UNDERDRAINED SOIL FILTER BASIN CROSS SECTION

SUPPLEMENTAL SUBMISSION

PORTION OF DETAIL SHEET 2 REVISION DATE APRIL 15, 2010.

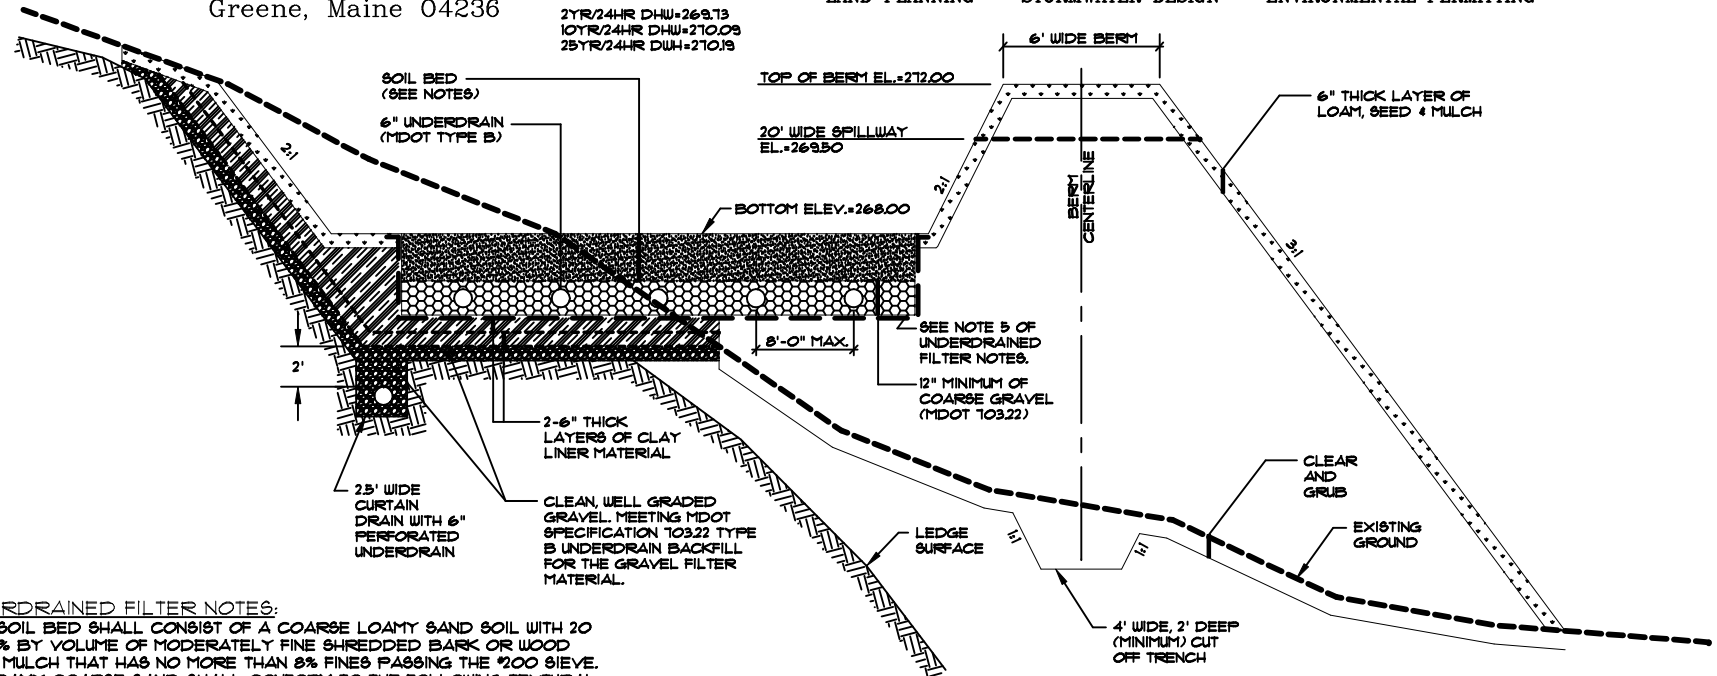
REVISED UNDERDRAINED SOIL FILTRATION BASIN CROSS SECTION TO ADD CLAY LINER SPECIFICATIONS

CLAY LINER SPECIFICATIONS

PROPER	TEST	THOD	UNIT	SPECIFICATION
PERMEABILITY	ASTM D-34		M/SEC X 10 ⁻⁶	
PLASTICITY INDEX OF CLAY	ASTM D-423/4		%	NOT LESS THAN 15
LIQUID LIMIT OF CLAY	ASTM D-2		%	NOT LESS THAN 30
CLAY PARTICLES PASSING	ASTM D-4		%	NOT LESS THAN 30
CLAY COMPACTION	ASTM D-2		%	95% OF STANDARD PROCTOR DENSITY
